Staff Report

To: BOZAR
From: Jessie Earley, Town Planner III
Meeting Date: DRC, March 17, 2025
RE: 422 and 422 ½ Sopris Avenue, Secondary Review

PROJECT TITLE: Breuer Residence (422 Sopris Avenue)

SUMMARY: Consideration of the application of **John Andrew Breuer and Amy Padgett Breuer** to site a new single-family residence and accessory dwelling to be located at 422 and 422 ½ Sopris Avenue, Block 35, Lots 5-6 in the R1C zone. *Continued from the January 28, 2025 BOZAR meeting.*
(Ryan/Hadley)

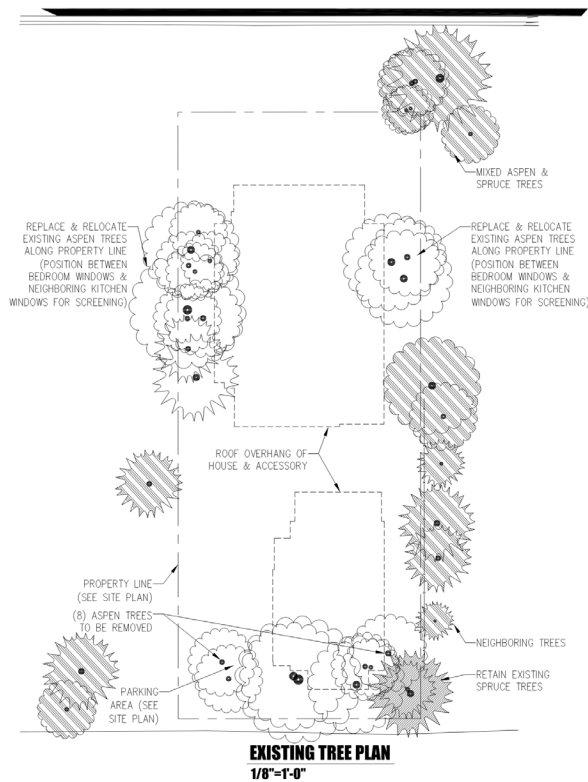
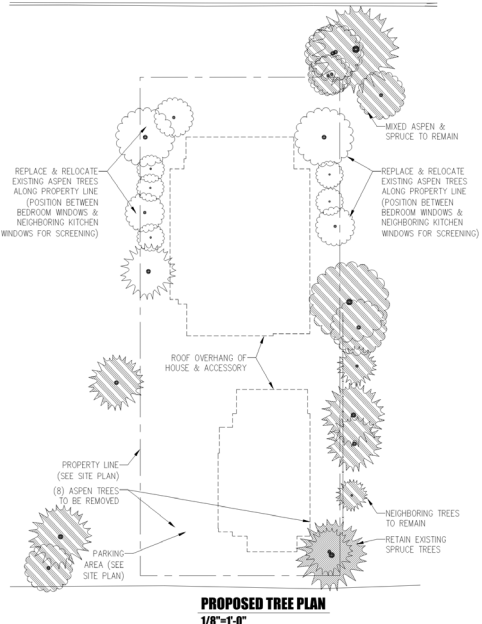
It appears that all trees that exist on the lot with the exception of the one spruce tree on the southeast corner will be removed. This is excessive and counter to other proposals the Board has reviewed and GL 2.18 a which speaks to trees within side setbacks. There have been other instances where soil nails were used to retain trees. Staff encourages potential retention of large trees on the east and west, thinning out smaller trees and as many trees to remain as possible. There is a suggested provision in the finding about the applicant hiring an arborist to help evaluate this.

1/28 BOZAR: Members had concerns regarding the trees.

<p>PROPOSED TREE PLAN 1/8"=1'-0"</p>	
<p>2.19 New trees</p>	<p>The applicant said in an email that they will conduct a “Tree Survey and Replanting Plan” which will document and catalog every tree above 3” caliper. Confirmation is needed of when this will be provided. This will help to determine how many trees will be removed and therefore need to be replaced.</p> <p>There are a cluster of new aspen trees (3) on the northwest corner of the lot and new evergreen trees (2) along the west.</p> <p>There is a new aspen and evergreen tree on the southwest corner of the lot.</p> <p>There are three new aspen trees noted on the eastern edge of the lot.</p> <p>Shrub buffers are noted on the west and east of the primary and the east of the ADU.</p>	<p>12/9 DRC: Members asked for a more detailed plan for what trees would be removed. This has been provided.</p> <p>1/13 DRC: Members noted that the existing and proposed trees would be a point of discussion for the full Board.</p> <p>1/28 BOZAR: Members had concerns regarding the trees.</p>

Proposed Site Plan (1/28/2025 BOZAR)

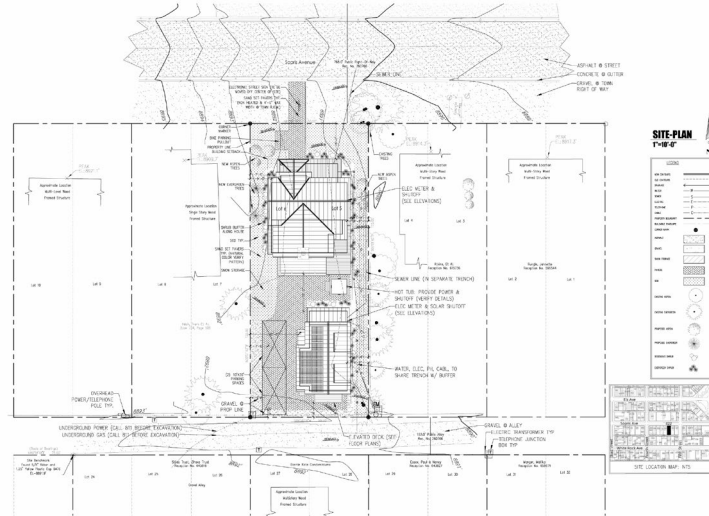
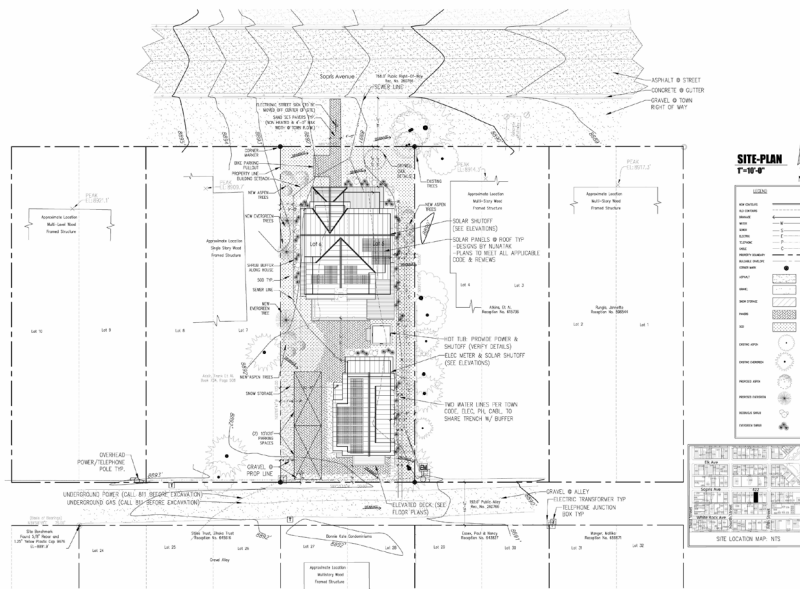
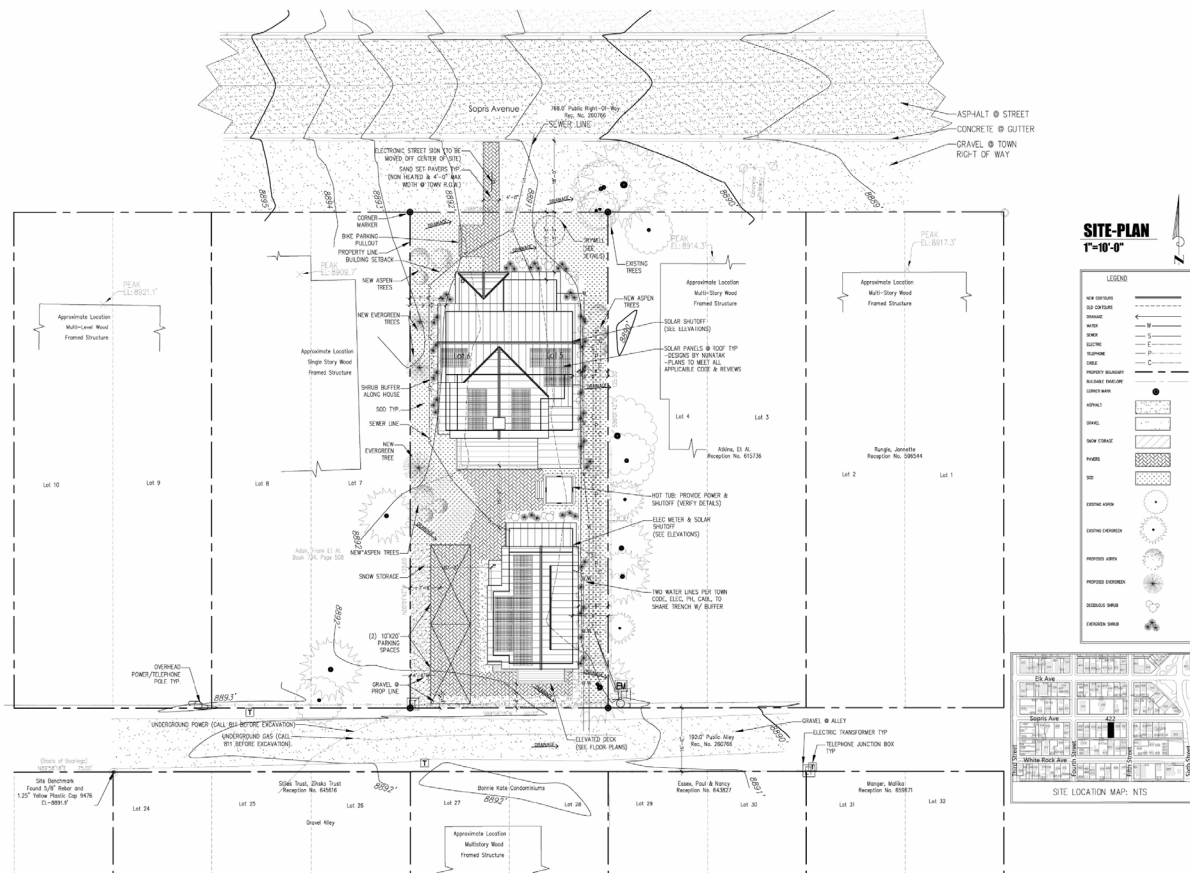
2.8 Drainage	Drainage swales are shown for the primary and accessory building to the east. However, drainage will need to be revised to encourage drainage to the alley or the street not the adjacent lot. A dry well is now shown on the north side of the lot. This will need to meet the specifications required by the Public Works Department.	12/9 DRC: Drainage cannot be to the neighboring property. Revisions needed 1/13 DRC: Drainage cannot be to the neighboring property. Revisions needed
Easements	NA	NA

<p>2.16 a./ 2.20 Native plantings</p>	<p>Sod is noted on the north portion of the property and on the east side of the structures. Generally, the GL supports use of native grasses. Discussion is encouraged.</p> <p>The applicant has mentioned in an email that they would be willing to provided native grass mix on the north side of the lot.</p>	
<p>2.16 e Pervious materials</p>	<p>There is a small area of gravel on the south side of the lot adjacent to the alley.</p> <p>The south portion of the lot and between buildings is called out as sand set pavers and was reduced from (2125.07 sf – 12/9 DRC) to (1286.35 sf -1/13 DRC) to (916.39 sf – 3/10 DRC). It is appreciated that the material is pervious.</p>	<p>12/9 DRC: Members expressed concerns regarding the amount of hardscape on the south. This was revised.</p> <p>1/13 DRC: The revisions were more well received. However,</p>

- Site Plan:
 - Pavers further reduced by:
 - Adding gravel at the garage dripline.
 - Reducing the South West patio & adding grass.
 - Removing the pavers under the Hot Tub & surrounding its concrete pad with grass.
 - Limited the entire length of the North walkway to 4'-0" wide.
 - Additional Evergreen & Aspen trees have been added to the South West yard, formerly the patio.
 - Drywell Added.
 - Sewer & Water Lines Separated.

Revised 3D – 3/17 DRC

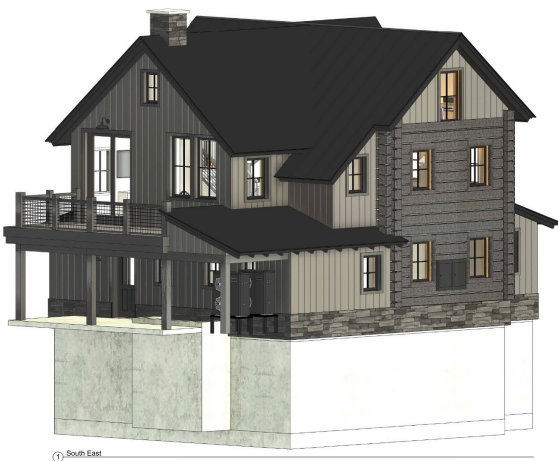
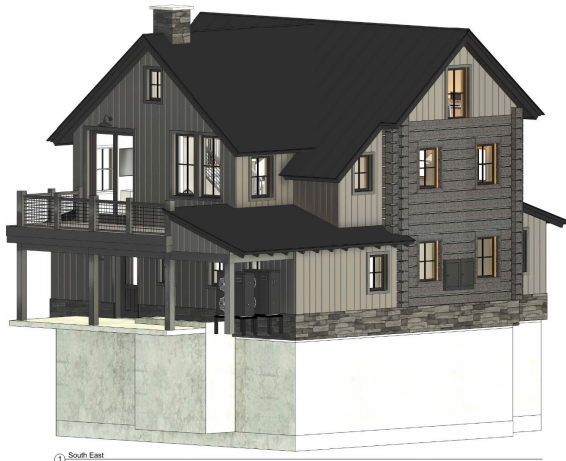
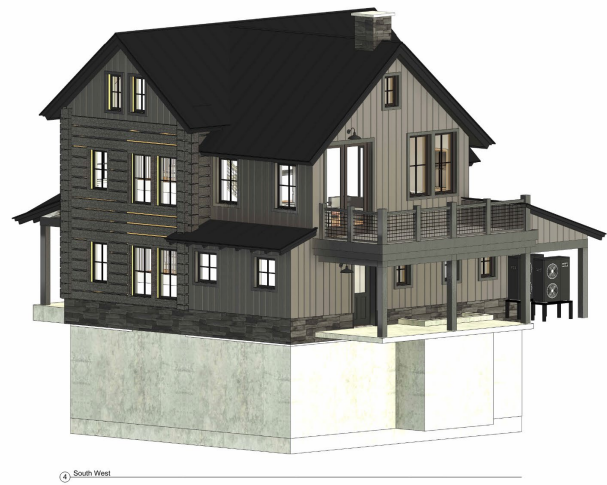
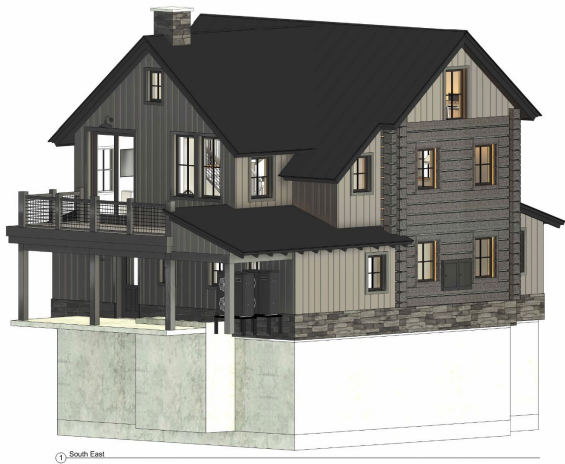
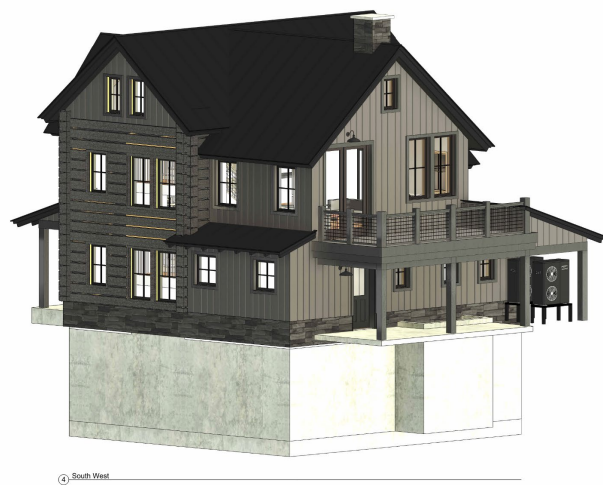
GL	Staff Analysis	DRC Recommendation
4.32-4.33	Consideration of whether the forms better achieve relationships with historic buildings are in GL 4.32-4.34. The 3D drawings are helpful in the review. The removal of the gable module perpendicular to the street and modification of the fenestration has helped to simplify this elevation.	12/9 DRC: Members requested a streetscape to better evaluate mass/scale and form as it relates to the context of the neighborhood. 1/13 DRC: Members had concerns regarding mass/scale/form as seen from the street per GL 4.32 a. One member

<p>GL 4.32 conveys that new infill construction should relate with the predominate scale of historic neighborhoods. An updated streetscape has been provided to assess this. 3D massing for streetscapes have been provided for other projects, which may be necessary. This building is at the height maximum of 28' and below the width maximum of 32' per zoning requirements. The design goals of this zone district encourage infill to help preserve the character of the existing buildings. Discussion is encouraged to determine if revisions are required. The applicant has removed the cricket, revised windows and reduced the height of the gable module by 12" from the previous application.</p> <p>Per GL 4.33, a diversity of forms is encouraged. Many of the homes on this south side of the block have a gable facing the street. The gable running parallel to the street varies this appearance.</p>	<p>felt that they could support, as drawn, but gave a suggestion to revise materials to help make the building less complicated. Siding materials have been revised in color.</p> <p>1/28 BOZAR: Members were concerned regarding the forms of the building per GL, as seen from the north/street side due to the contemporary nature.</p> <p>3/10 DRC: Members appreciated the responsiveness from the applicants for removing the front gable. However they felt that this change made the building look more massive and therefore did not fit with mass/scale/form GL It was discussed that the front gable helped to break up the mass, but revisions were encouraged. The applicant has provided revised drawings.</p>

The plans were reviewed once back in Town Hall. Members felt that the removal of the gable element was a detriment to the mass/scale and form, as it looked more massive. IT was encouraged to add it back with simplification of other elements.

- Streetscape: Updated to reflect the below revisions to the primary building.
- House Design:
 - North lower porch cricket removed.
 - The 2nd floor kitchen windows, reduced from three to two.

- The loft level bathroom window has been eliminated.
 - The North gable roof (loft bathroom) has been brought down 12".
- Garage(s):
 - The applicants are showing three different roof proposals for the accessory dwelling to discuss.

Revised Front Porch – (3/17/2025 DRC)

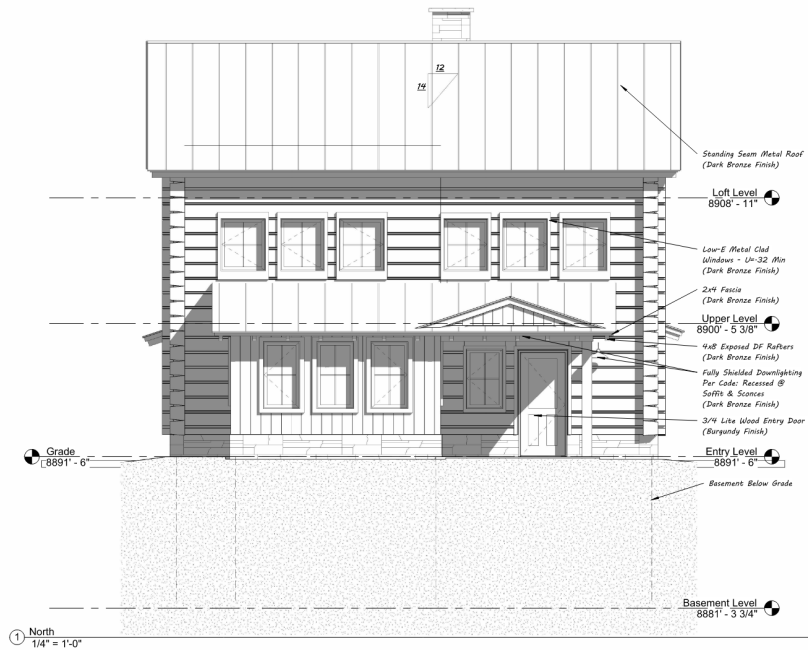
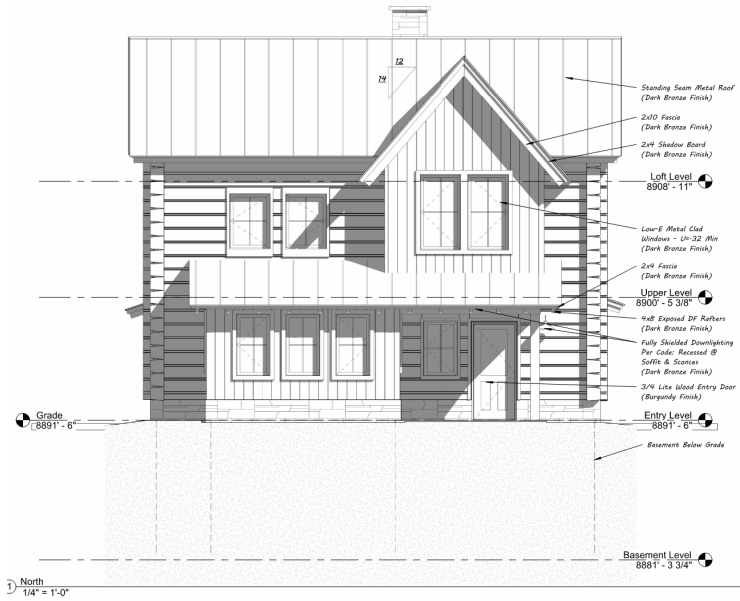
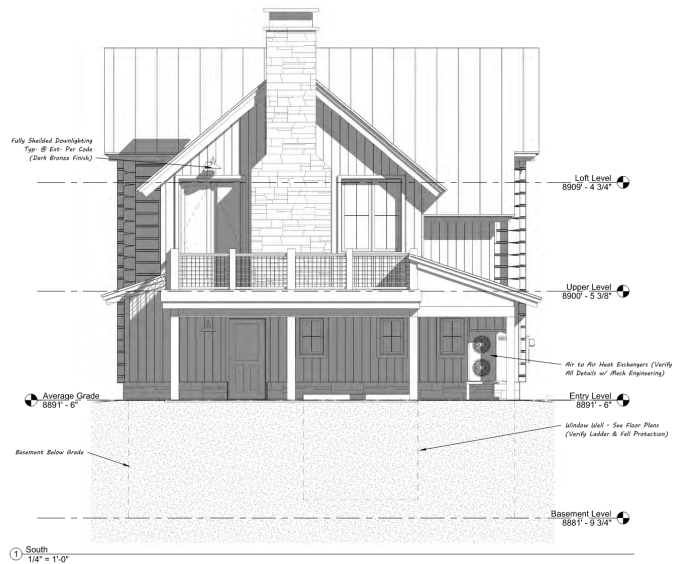
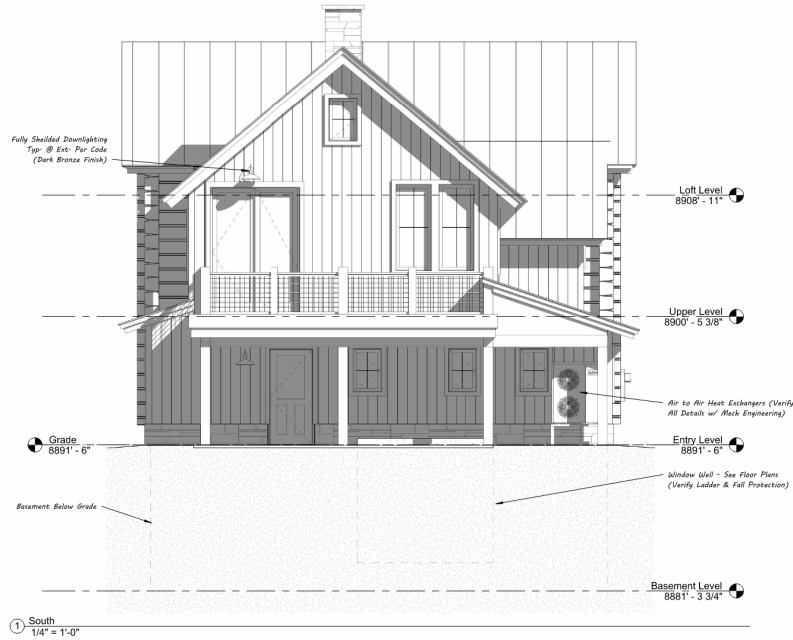
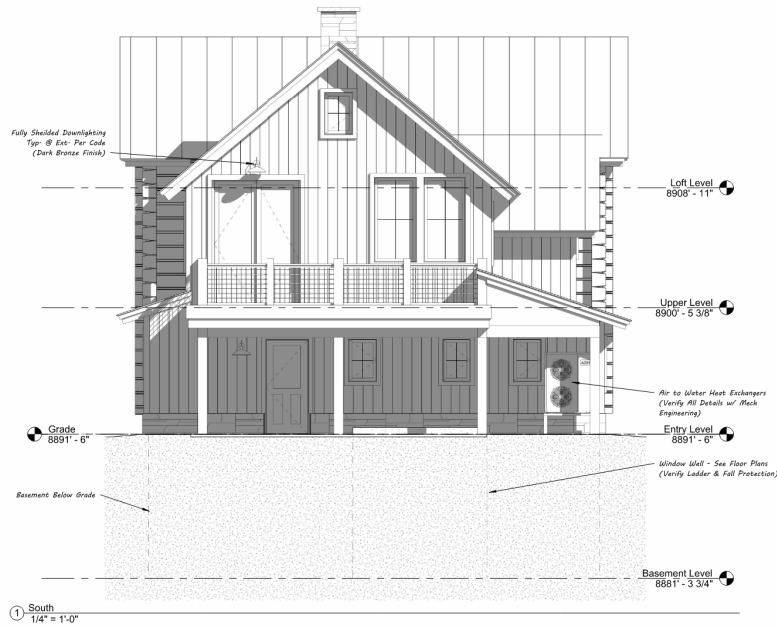
GL	Staff Analysis	DRC Recommendation
4.49/5.118 Primary entrance porch	<p>These GL encourage clearly defining the entry, which is done in many cases with a porch as seen on many historic buildings and also on this building. General support.</p> <p>The cricket was removed from this porch to help simplify the elevation.</p>	Support
4.50 Mix of porch sizes	The front porch is 8'x10'6", which meets the intents of this GL.	Support
4.51 Rear entry porch	The porch on the rear is simpler with the	Support

Option 1: 3/17/2025 DRC

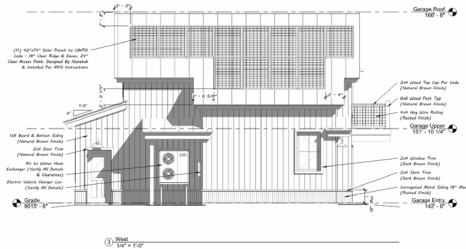
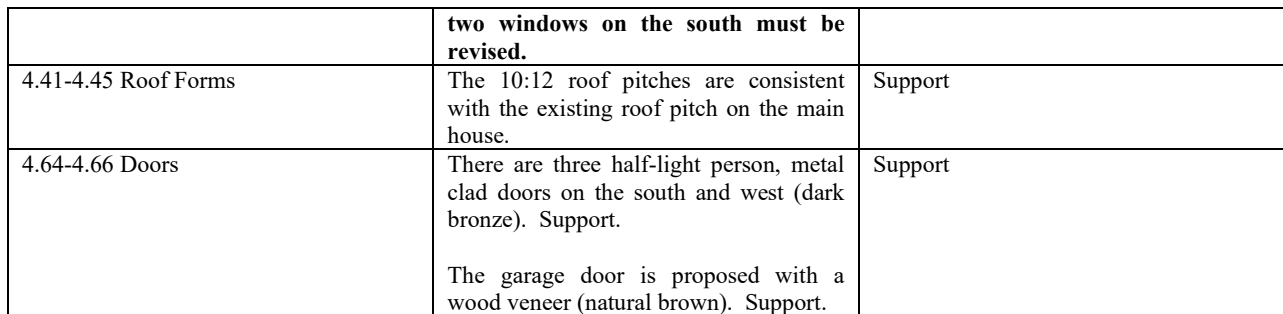
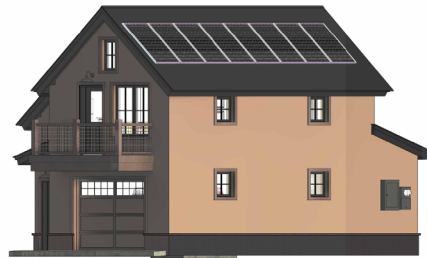
GL	Staff Analysis	DRC Recommendation
4.46 Dormers in new construction	There are two shed roof elements proposed for the east elevation, as was proposed in the original design. Discussion is needed to determine if the Board considers this a dormer. If so, it is a shed dormer, which is supported by this GL.	1/13 DRC: Members expressed that this is a dormer. 1/28 BOZAR: Members expressed that the large element was a dormer and needed to meet the GL. 3/10 DRC: Members expressed support for the dormers as proposed. However they asked that the applicants provide justification. This has been provided.

4.47 Dormers	The two shed dormers steps down 1'10" from the ridge of the garage module and achieves subordination. a. As proposed the two occupy 29.7% of the roof. b. The dormers are lower than the ridge. There is not a section of roof beneath either, as required in core zones. c. As proposed the two occupy 29.7% of the roof. d. The proposed shed dormers extend	1/13 DRC: Members expressed that this was a dormer due to the language in 4.47 b. requiring it in core zones. With that in mind, it doesn't comply with GL noted. 1/28 BOZAR: Members expressed that the large element was a dormer and needed to meet the GL. 3/10 DRC: Members expressed support

<p>past the middle third on both the south and north sides.</p> <p>e. Met.</p>	<p>for the dormers as proposed. However they asked that the applicants provide justification. This has been provided.</p>
4.87 Dormers on ADU	<p>4.87 b. See above.</p> <p>c. Both break the eave line and aren't less than 3' than 24'.</p> <p>d. NA</p>	<p>1/28 BOZAR: Members expressed that the large element was a dormer and needed to meet the GL.</p>

The ADU dormers were discussed and members felt that they could support the elements. However they encouraged the applicants providing images and justification for how this was arrived at.

- (X.1) This garage displays what the applicants feel is the best option in terms of habitability of the ADU. They are showing two "Roof Elements" each with 4'-0" tall windows allowing for maximum light, ventilation, views & egress.

- (X.2) This garage displays what the applicant's feel guidelines state as allowable. They are showing two "Dormers" each with the higher roof continuing through the exterior wall & thereby limiting the window size. This design to the applicant feels unbalanced with the expanse of wall below the roof & above the lower windows. Additionally these dormers get pushed up to the ridge, against the guidelines, to allow even a small window with very limited sky views & light.

- (X.3) This garage has no dormers or roof elements. The applicants feel that it is the most unlivable.
- Site Plan: Matt has engaged an Arborist & they will be producing a tree viability report shortly.
